Sheridan Health HRSA Grant Reno PN 23-180545

ADDENDUM 1

SHERIDAN HEALTH SERVICES
SUITE REMODELS

G-001

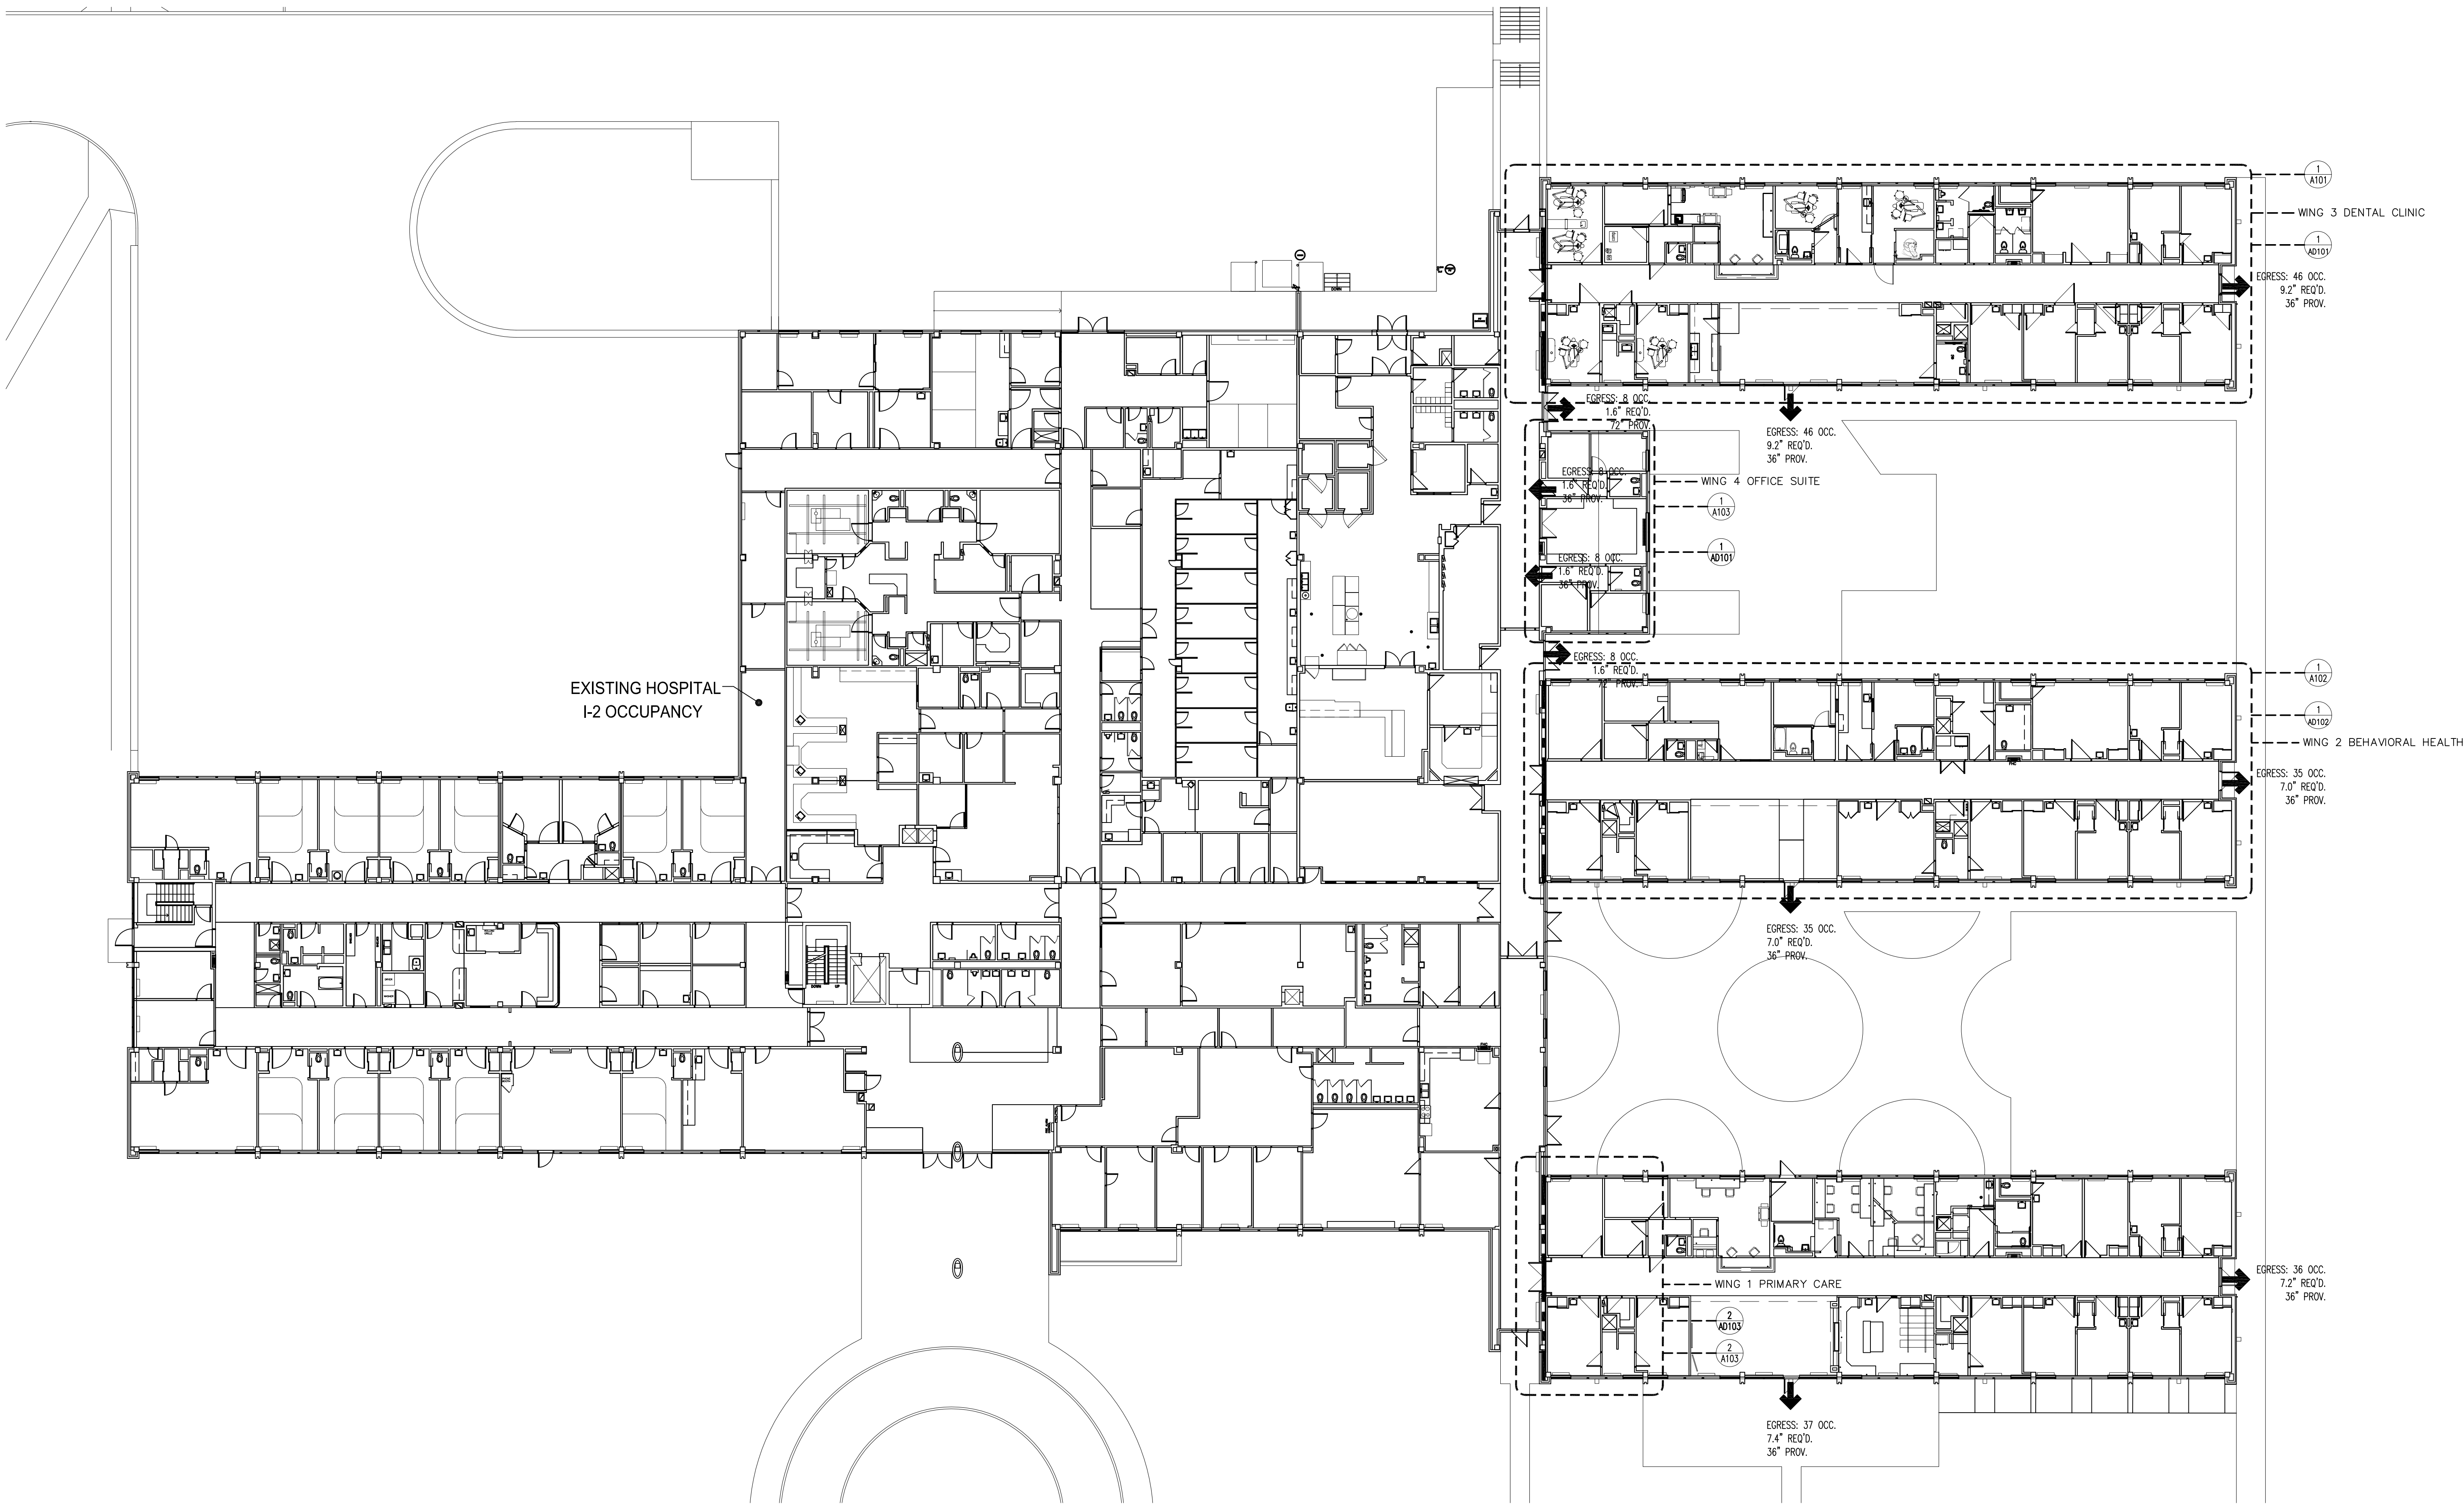
- 1) See the attached and most recent 100% drawings and manual. Make note that Ad Alt #3 was removed from the list (G001 in drawings).
- 2) See the attached asbestos test results. CU will be responsible for the abatement work.
- 3) Work will be done in two phases. Wings 2 & 4 will be the first phase and wing 3 will be the second phase.

- ADD ALT #1: DEMO: REMOVE DOOR LOCK SETS.
NEW CONSTRUCTION: INSTALL NEW DOOR HARDWARE, INSTALL NEW WORKSPACE
COUNTERTOPS, PAINT WALLS AS NOTED.
- ADD ALT #2: ADD POWER OPENERS TO EXISTING DOORS.
- ADD ALT #3: NOT USED
- ADD ALT #4: DEMO: DEMO EXISTING HANDRAILS.
NEW CONSTRUCTION: SPOT PATCH, PAINT, AND REPAIR WALLS.
